**RIVERSIDE PARK  
MASTER PLAN**

**RIVERSIDE PARK  
WEST  
CONCEPTS &  
PUBLIC INPUT**

**RE:** Riverside Park West and Riverside Drive West Improvements Study  
Workshop Findings

**From:** Steve Szabo [SSzabo@jonesedmunds.com]  
**Sent:** Wednesday, April 09, 2008 1:57 PM  
**To:** Frank Woodard; Chris Lukowiak; Tanya Lukowiak  
**Cc:** Geoff Seger; Steve Starr; Steve Szabo; Jim Mclellan; BRIAN HEPBURN  
**Subject:** RE: Review Comments- Riverside Park

**RIVERSIDE PARK WEST  
PROPOSED  
IMPROVEMENTS**

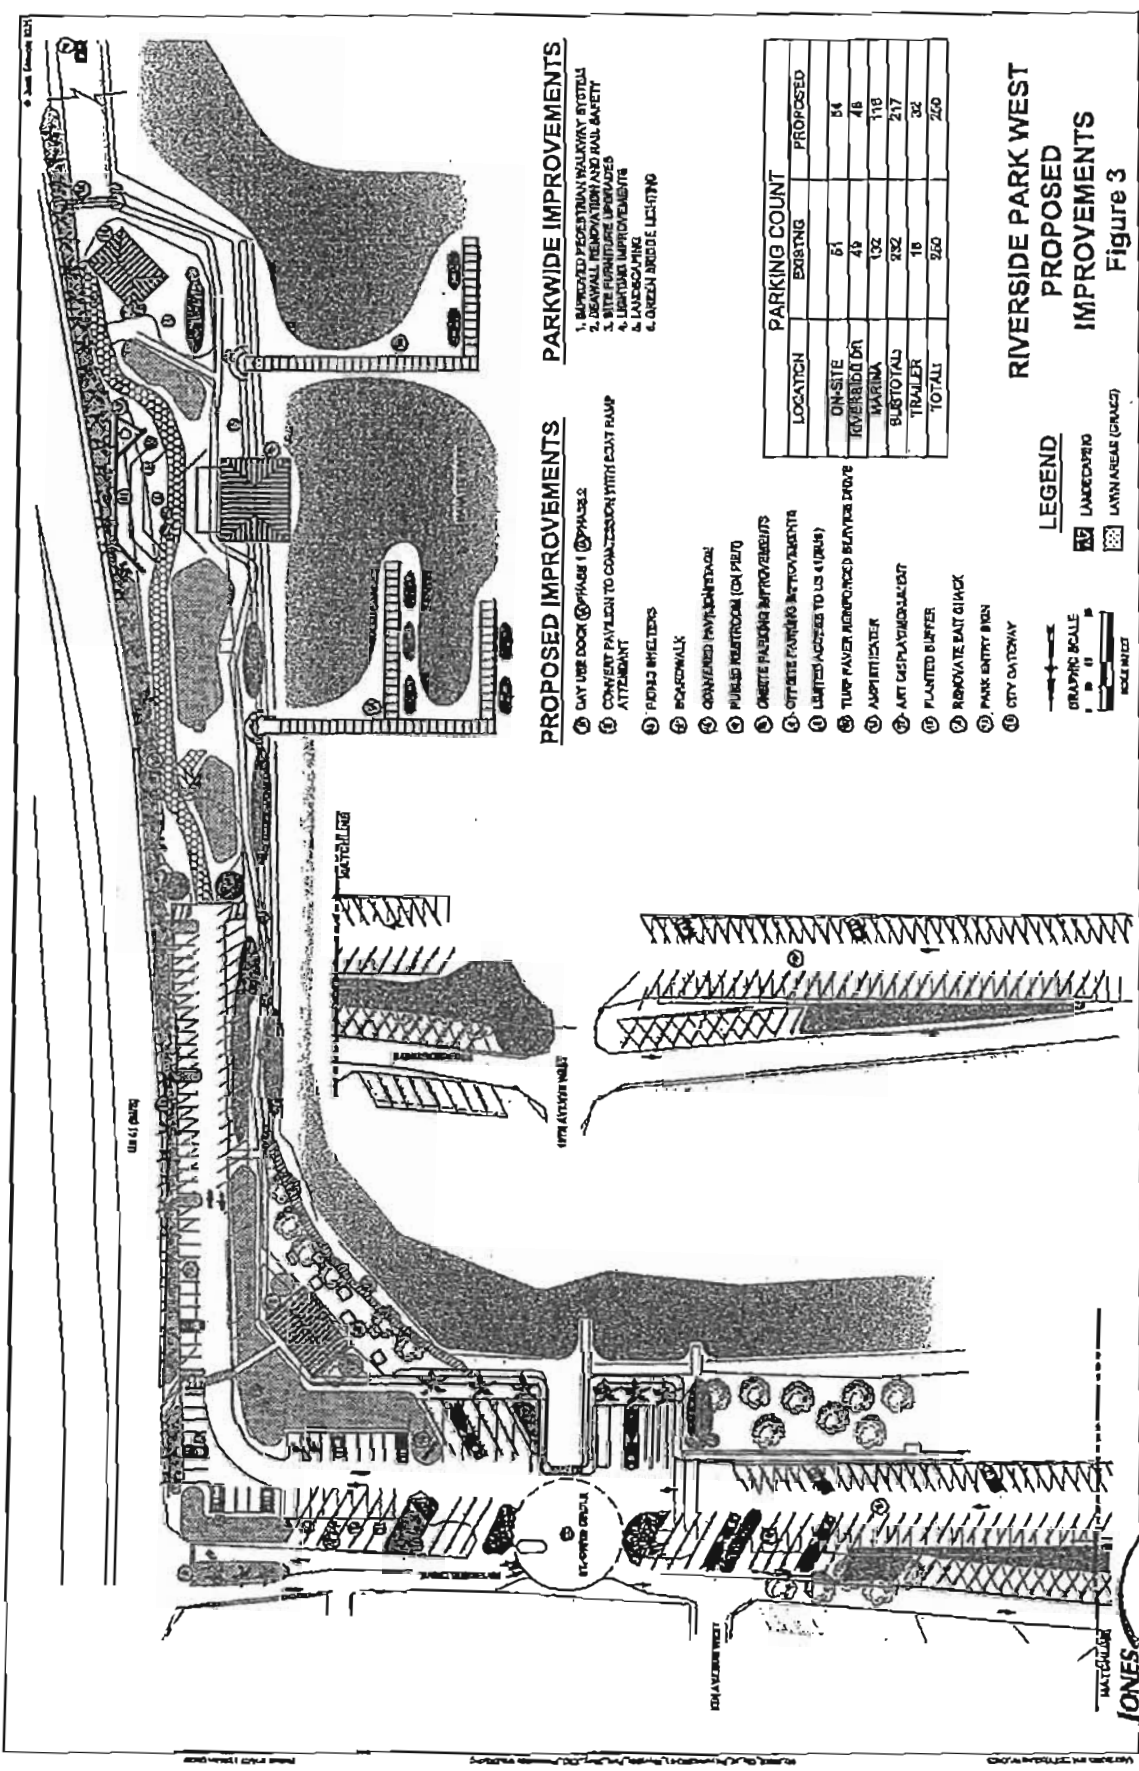
- Buffering US Bus 41 from the park without compromising security.
- Relocating the bait shop is preferred. Having one is important and creates a certain positive ambiance for a waterfront community gathering spot.
- Re-opening the bait shack bathrooms or building new ones on the pier was suggested by a member of the public. It was reported that the pier often smells of urine.
- Many members of the public liked the idea of boaters having dock access to the park.

- A member of the public mentioned that an effort should be made to reduce the amount of pavement since it retains heat.
- The Mayor mentioned the idea of having valet parking for boat trailers during peak times.

- A member of the public suggested selling boat trailer passes or charging a launching fee of \$10 (similar to Pinellas County).
- It was suggested that illegal parking be monitored and enforced.

- The Mayor cited the San Antonio Riverwalk as an example of a good waterside public gathering area.
- The potential of displacing parking with a new public parking garage at the corner of 10<sup>th</sup> and Riverside was discussed.

- The idea of expanding or eliminating the Riverside Park East parking lot was discussed. It was also mentioned that the options are very limited for that area due to the size of the parcel of land.

- For special events, a member of the public suggested using a shuttle to minimize parking issues.

- Install public docks for use
- Retrofit lights with period style-fixtures
- Trim/clear mangroves near existing pavilion
- Improve the seawall/install railing
- Improve the parking situation

- Improving the northbound left turn from Riverside Park West
- Separating business US 41 from the park (i.e. - calming traffic along Riverside Drive)
- Incorporating art into the park
- Providing an amphitheatre

Based on the public's and staff's feedback, Jones Edmunds has prepared a prioritized list of park improvements. The attached draft conceptual sketch addresses the majority of public's and

staff's wishes. The proposed improvements are prioritized in order of importance and in a chronologic order that allows flexibility in phasing. The one item that has not been addressed is a pedestrian crossing of US Bus 41.

At this time, Jones Edmunds is still evaluating height requirements and permitting feasibility of the possibility of a route under the Green Bridge. Also, the traffic study is still in progress which may effect the Riverside Drive Improvements.

**RIVERSIDE PARK WEST  
PROPOSED  
IMPROVEMENTS**

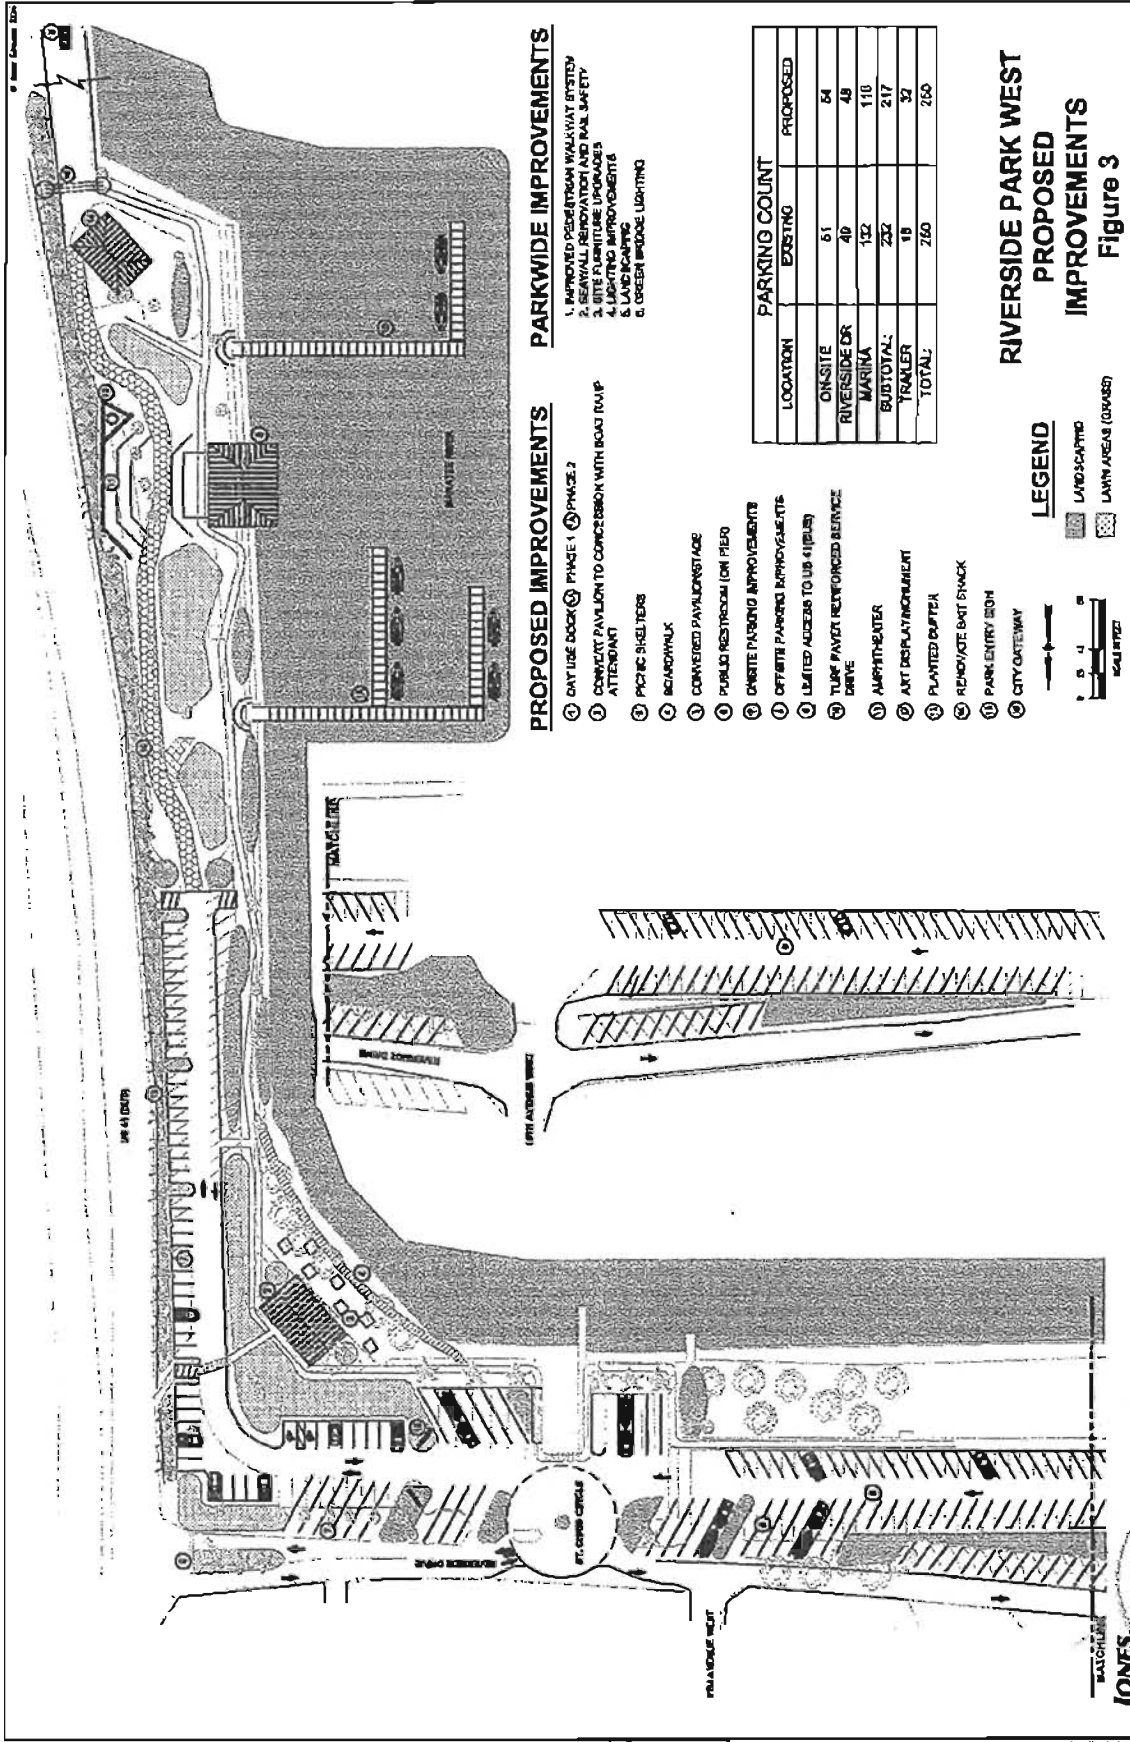
7. The south end of the parking lot will need a turn around for emergency vehicles.
8. All parking spaces should be slanted to allow for better visibility.
9. Shorten day docks to avoid conflicts with boat traffic using the ramp.
10. Move "St. Chris' Circle" to 10<sup>th</sup> Avenue West to avoid conflicts with parking lot traffic and boat ramp.
11. Riverside Dr. should remain a two street to avoid moving traffic thru a parking lot.
12. Need to include a cantilever under 8<sup>th</sup> Ave. bridge for access Riverside Dr. east.

1. The south end of the parking lot will need a turn around for emergency vehicles. **Jones Edmunds: We are currently showing a "no parking area" at the south end of the parking lot. The area consists of a "hammerhead", t-shaped turn around. Since the proposed parking is 90 degree, a cul-de-sac should not be required unless required/preferred by the City. Per the City Workshop, the intent was to minimize the amount of pavement in the park. Please advise if the City would like to keep the existing cul-de-sac.**

2. All parking spaces should be slanted to allow for better visibility. **Jones Edmunds: The intent of the 90 degree parking was to provide more "linear green space" along the park. If 60 degree parking is preferred, we suggest keeping the parking on both sides of the drive aisle and keeping the cul-de-sac. Essentially, keep the parking lot along Bus US 41 as-is. Please advice if the City would like to keep the existing parking along Bus US 41 as-is.**

3. Shorten day docks to avoid conflicts with boat traffic using the ramp. **Jones Edmunds: Comment accepted.**
4. Move "St. Chris' Circle" to 10<sup>th</sup> Avenue West to avoid conflicts with parking lot traffic and boat ramp. **Jones Edmunds: Comment accepted based on comment #5 below. Please note that the boat ramp requires a large paved area for maneuvering trailers.**

5. Riverside Dr. should remain a two street to avoid moving traffic thru a parking lot. **Jones Edmunds: Comment accepted.**
6. Need to include a cantilever under 8<sup>th</sup> Ave. bridge for access Riverside Dr. east. **Jones Edmunds: Comment accepted and will be incorporated. It should be noted that there is minimal vertical clearance (+/- 8'-10') between the bridge beams and the water surface under the 8<sup>th</sup> Ave. bridge. Also, we have some safety concerns siting a walkway under the bridge. Jones Edmunds suggests consulting with Palmetto PD on CEPTD requirements. We understand that a pedestrian bridge or signalized crosswalks were previously considered at Riverside Drive.**
